1317 N TEJON ST NORTH-SIDE WINDOW AND EAST DOOR PROJECT

Historic Preservation Board – October 7, 2024

Staff Report by City Planner: Johnny Malpica

File Number	Application Type	Decision Type
HIST-24-0014	Report of Acceptability	Quasi-Judicial

A
A-2 PROPOSED NORTH WINDOW
SCALE: 1"=1'

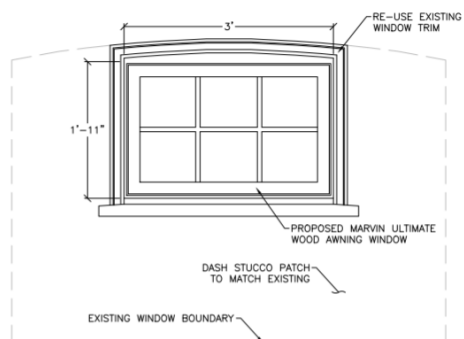
The project proposes the conversion of an existing glass bay window along the northern side of the house with a traditional style wood awning window that matches the architectural vernacular of the primary structure. Additionally, the proposal includes the replacement of an eastern (rear) double window with a wooden double door of a traditional style that includes a new staircase with four risers and a railing. Both of the changes included in this Report of Acceptability demonstrate attention to the structure's architectural vernacular and historical significance. Additionally, it should be noted that the existing bay window on the side of the home is averse to the building's architectural style, both from a stylistic and material perspective. The proposed replacement window is both aesthetically and materialistically consistent with the structure's architectural fenestration. As such, the side window replacement represents an improvement to the building's historic architectural style. The rear door with staircase is both minimally visible from public view and matches the building's architectural form and fenestration and is expected to have a minimal impact to the historic value of the home and property it is seated on.

According to North End Standards, the project site is located within the Nevada/Tejon Corridor. Provided that the proposal consists of the replacement of a bay window that is averse to the building's historic significance with one that is historically derivative of the building's intended architectural style, and the rear window replacement with a rear door that is consistent with the building's architecture, the projects size, location, and materials used have no impact to the original historic structures on the property. As such, the project is consistent with the North End Standards as described below:

B PROPOSED EAST DOOR
A-2 SCALE: 1/2"=1'

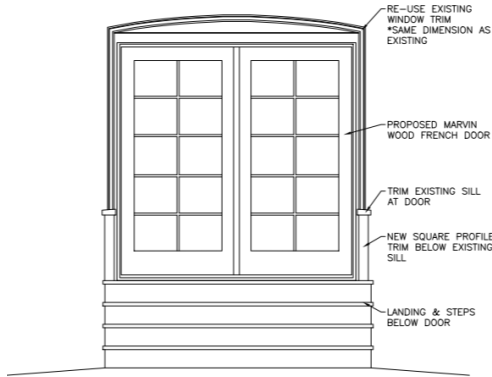
This project maintains the visual integrity of the Old North End Historic District through the use of traditionally styled wooded windows and doors with divided light grills. Furthermore, the steps that serve the rear doors integrate features including stained wood like decking, iron guardrails, and a lattice skirt that are consistent with the overlay zone.

C PROPOSED EAST DOOR STEPS
A-2 SCALE: 1/2"=1'

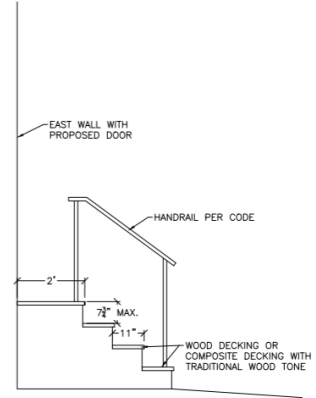
The placement of the patio door and steps are done so to as to be oriented along the southern side of the primary structure, maintaining a setback that is consistent with that of the existing home, where porch features are aligned along the southern side of the home.
